HISTORIC DISTRICTS REVIEW BOARD FIELD TRIP

TUESDAY, April 12, 2016 at 12:00 NOON

SUMMARY INDEX
HISTORIC DISTRICTS REVIEW BOARD

MINUTES OF THE
CITY OF SANTA FÉ
HISTORIC DISTRICTS REVIEW BOARD

718-714 front elevations Gregory Lane

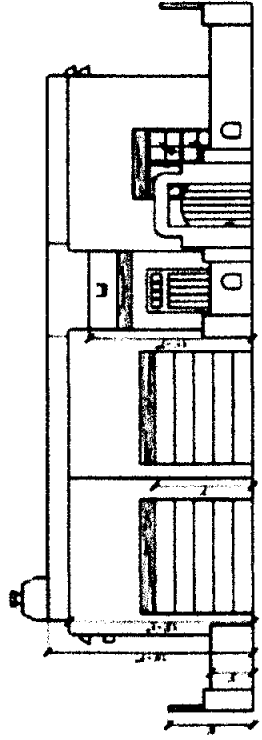
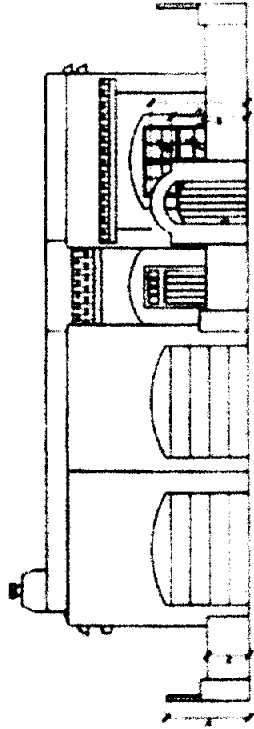
One thing that bothered her is that both designs are exactly the same - the floor plan is identical - and that normally does not take place in historic neighborhoods. She showed what was submitted years ago and they are two entirely different homes.

I do have one major concern that I would like to address, which is the double garages on the front facades of both residences. While there are instances of double garages for a single residence within the Don Gaspar District, they are in general the exception, not the rule. The prevailing design in the neighborhood is a single-car garage for each house. Most importantly, the garages are, in almost all instances, partially hidden behind a residence or significantly set back from the street. The inclusion of a double garage in both residences with a setback of only 20 feet is a substantial departure from both the style and character of the neighborhood. While I appreciate their amendment to the design that set backs the one garage an additional few feet, I still find the designs to be an egregious divergence from residences in both the immediate vicinity and the district as a whole. For example, 801 and 803 Don Cubero Avenue, residences designated "significant" by the City of Santa Fe, are approximately two blocks from the proposed new construction on Gregory Lane. They share a double garage between them, but it is setback from the street/curb approximately 80 feet. (see below).
